# Access Compliance Report

## Public Rights-of-Way

### (Curb Ramps)

Intersection ID: 11615	Main Street: E_18TH_ST	Cross Street: N_ALEXANDER_ST	Location: NE
ADA ID: A48030D7A89A	Ramp Type: Perp	Initial Pass/Fail: Fail	Overall Compliance: No
Severity Score: 67.5			
Codes/Mitigation Info/Possible Solution		Field Measurements/Component Compliance

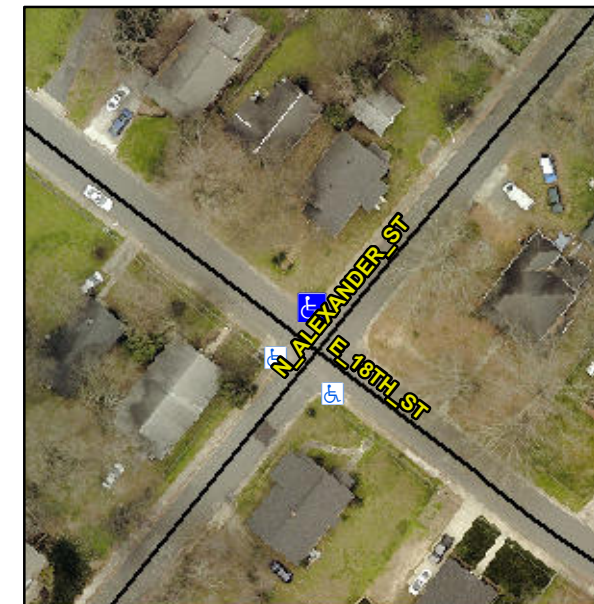
**Not Found, R304.5.1, R304.2.2, R304.5.3**

Compliance	Description	Data	Compliance	Description	Data
N/A	Ramp Length (in)	56.0	No	Ramp Slope (%)	14.8
No	Ramp Width (in)	35.0	No	Ramp XSlope (%)	11.6
N/A	Flare Type LT	N/A	N/A	Flare Type RT	N/A
N/A	Flare Slope LT (%)	N/A	N/A	Flare Slope RT (%)	N/A
N/A	Flare Traversable LT?	N/A	N/A	Flare Traversable RT?	N/A
N/A	Landing Length (in)	N/A	N/A	DWS Provided?	N/A
N/A	Landing Width (in)	N/A	N/A	DWS Contrast?	N/A
N/A	Landing Slope (%)	N/A	N/A	DWS Length (in)	N/A
N/A	Landing X Slope (%)	N/A	N/A	DWS Full Width?	N/A
N/A	Landing Curb? (Y/N)	N/A	N/A	DWS Offset (in)	N/A
N/A	Shared Landing?	N/A			
N/A	Gutter Ponding?	N/A	N/A	Gutter Slope (%)	N/A
N/A	Gutter Lip Ht (in)	0.5	N/A	Gutter X Slope (%)	N/A
N/A	Painted X Walk1?	No	N/A	Painted X Walk2?	N/A
	X Walk 1 Direction	To SW		X Walk 2 Direction	N/A
N/A	X Walk 1 Width (in)	N/A	N/A	X Walk 2 Width (in)	N/A
	X Walk 1 Slope (%)	0.4		X Walk 2 Slope (%)	N/A
	X Walk 1 X Slope (%)	2.9		X Walk 2 X Slope (%)	N/A

**Remove & Replace Entire Ramp.**
